Response to a Second Request for Additional Information Regarding ANP-10284, "U.S. EPR Instrumentation and Control Diversity and Defense-In-Depth Methodology Topical Report" (TAC No. MD5884)

Response to Second Request for Additional Information – ANP-10284
“U.S. EPR Instrumentation and Control Diversity and Defense in Depth [D3] Methodology
Topical Report” (TAC No. MD5884)

Figure RAI 18-1: Process Automation System (Diverse Actuation Subsystem)

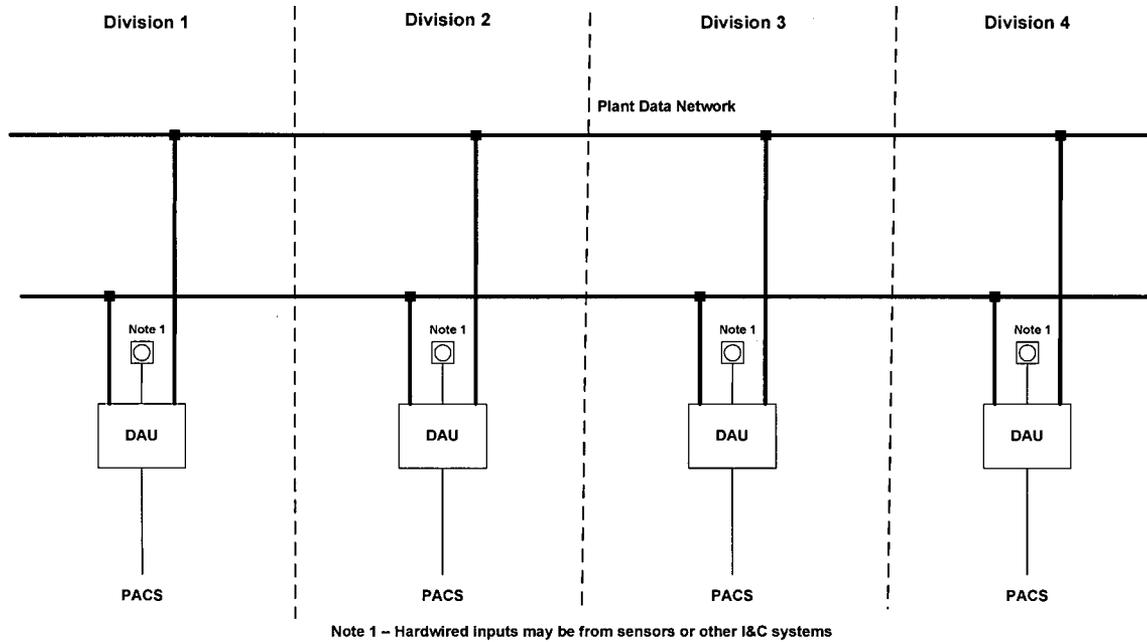
RAI-18: *What is the architecture of the DAS as it relates to the PAS? Is the DAS implemented on its own hardware/software component within the PAS system, or is it implemented on the same hardware as other PAS functions as a particular software function? Please provide detailed explanation.*

The DAS is organized in four redundant divisions located in separate Safeguards Buildings. Each division of DAS contains diverse actuation units (DAU). The arrangement of the DAS is shown in Figure RAI 18-1. Hardwired signals can be acquired from sensors or other I&C systems. The method of acquiring signals from the Protection System (PS) is described in RAI-19 response. Fiber optic data connections are provided to share trip requests, and two out of four voting is done in each DAU. Outputs are sent to the Priority and Actuator Control System (PACS) via hardwired connections. The DAU's interface with the Process Information and Control System (PICS) via the plant data network for the display of information.

The DAS functions are implemented on hardware and software contained in the DAU, which is separate from the equipment used to implement other PAS functions in the other subsystems of PAS. Segregation is achieved by housing the DAS hardware in cabinets separate from the other PAS cabinets. Figures RAI 18-2 and RAI 18-3 illustrate the architectures for the other PAS subsystems (NIS, TIS, and BPS). Control Units (CU) contain the processors in the other PAS subsystems. The PAS subsystems are interconnected via the plant data network. The PAS is a completely diverse system from the PS in hardware and software.
